SUBJECT: RAPID RESPONSE TRANSMITTAL/SERVICE ACTION #09-037
Passenger Side - Heated Seat Wire Retention

INVOLVED VEHICLES:

2008 - 2009 (LC) Challenger

2008 - 2009 (LZ) SRT8 Challenger

Figure 1

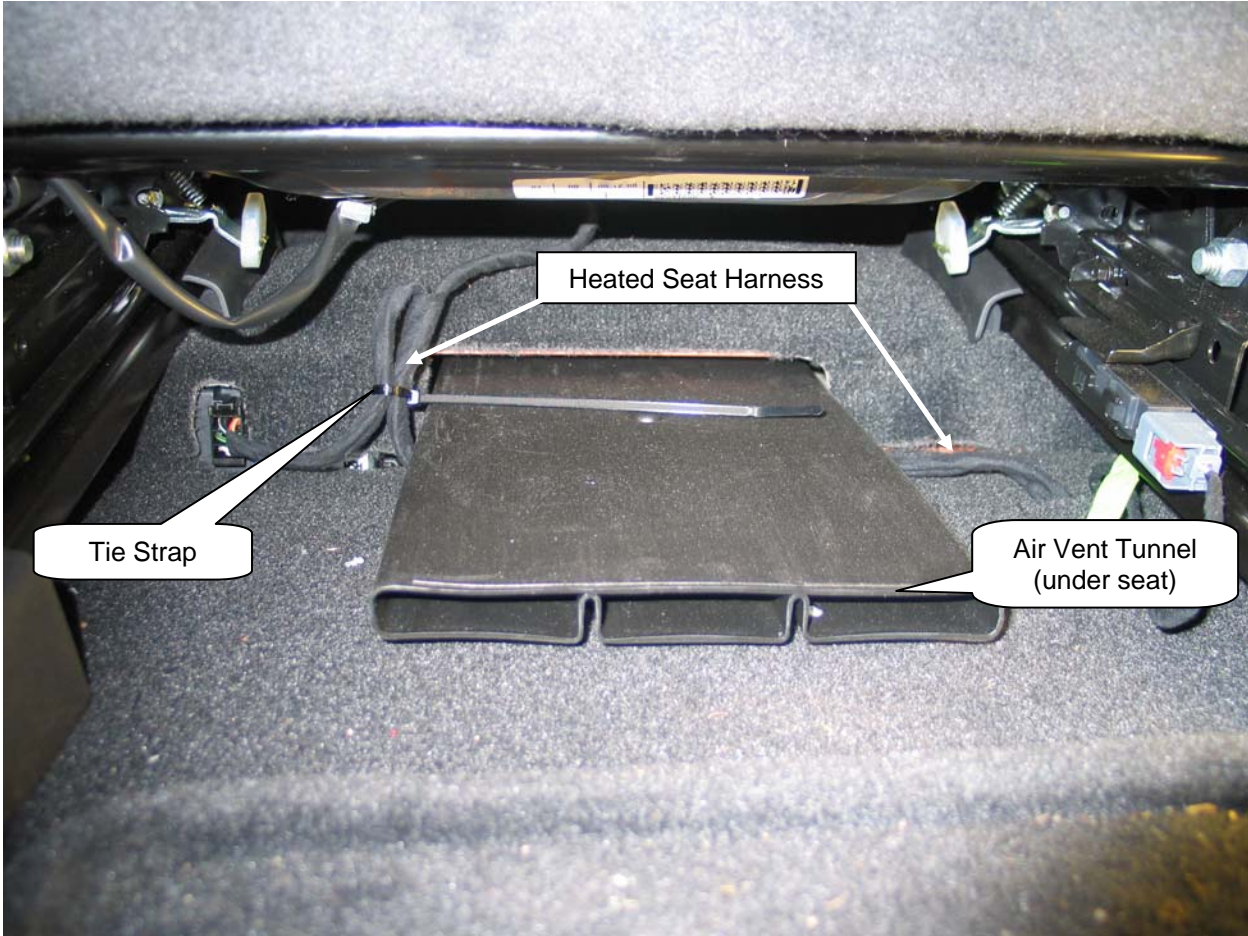
A number of vehicles with heated seats (Sales Code JPM) were shipped with the passenger side heated seat wire positioned where it could pull on the electrical connector and unplug the heated seat module. Dealers are required to secure the wire out of the way with a tie strap.

1. Position right side (passenger) seat all the way forward and tilt seat back all the way forward.
2. Gather up the excess length of wire from under the air vent tunnel toward the center of the vehicle (Fig.1).
3. Add the tie strap to keep the harness in place (Fig. 1).
4. Return vehicle to Inventory or the Customer.
